SOILS STUDIES & OPINION REPORTS

PRELIMINARY ENGINEERING GEOLOGIC REPORT TO PARK CITY ON
THE PROPOSED QUITTIN TIME DEVELOPMENT

by
William Lund, Geologist

Done at the request of the Park City planner.
May 1979

Figure 2 Location of Test Holes (Modified from consultants report)

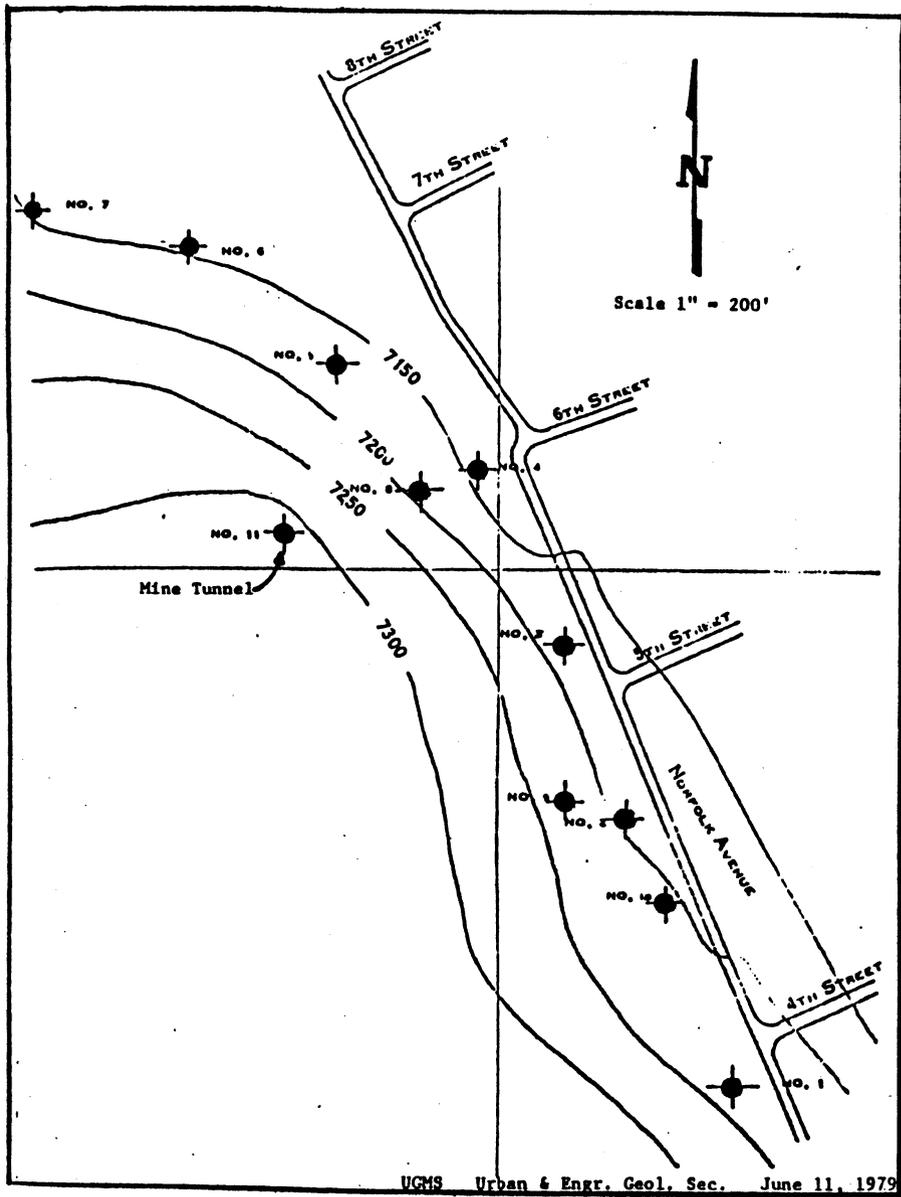
During this investigation nine of ten backhoe pits excavated by a private consulting firm which had previously prepared a report on this property were examined (Figure 2). Prior to the field reconnaissance, four of these test holes were cleaned out by the Park City backhoe. The five remaining holes were not cleaned, either because they were inaccessible due to installation of a new municipal waterline across the site, or because they could not be located by the equipment operator. The four test holes which were cleaned, nos. 1, 4, 5, and 10 of the consultant's

report, were all reported to have reached bedrock at depths ranging from seven to nine feet below the ground surface. Groundwater was encountered at a depth of eight feet in test hole no.10, and this prevented the excavation from being adequately cleaned. As a result no determination could be made regarding the presence of bedrock. Test holes 1 and 4 were both cleaned to their original depths, but an inspection showed that neither of the two had reached solid, in place rock. Instead, both excavations stopped at a dense, closely packed layer of quartzite cobbles and boulders in a clay matrix. This material appears to be sufficiently compact to resist excavation by all but the largest of backhoes, and may represent the zone of broken and weathered material that commonly mantles in place bedrock. However, since the excavations did not penetrate this horizon, its true thickness and relationship to the underlying bedrock is not known. Test Hole No. 5 was excavated one foot below original grade and bedrock was not encountered. The walls of the five remaining test holes had all sluffed to some degree, consequently, bedrock could be positively identified only in test hole no. 6. The tenth test hole, no. 3 of the consultant's report, had been backfilled and could not be located.

The soils exposed in the test holes generally conform to the descriptions provided in the consultant's report (Appendix A). The only significant difference concerns the description of the Zone 2 soils. This soil horizon is described in the consultant's report as a granular zone composed of angular fragments in a silt matrix, and is classified in their logs in accordance with the

United Soil Classification System as a silty gravel. Such a description implies that the material is non- to only slightly-cohesive and possesses no or only very low plasticity. The soils which correspond to Zone No. 2 observed in the test holes were found to contain a considerable amount of clay and as a group are probably better classified as a clayey gravel and in some localities even a gravelly clay.

1. Zone 2 soils should be reclassified as clayey gravels and locally as gravelly clays to reflect their cohesive nature and high clay content.
2. A dense layer of quartzite cobbles and boulders in a clay matrix exposed at the bottom of test holes 1 and 4 appears to have been erroneously identified in the consultant's report as bedrock. Bedrock could be positively identified in only one of the nine test holes examined, but five of the pits had not been adequately cleared and therefore a determination as to whether bedrock was present or not couldn't be made. Bedrock was also reported in test hole No. 5, however, the excavation was cleaned a foot below original grade and no sign of any rock was observed (see note test hole No. 5 in Appendix A)
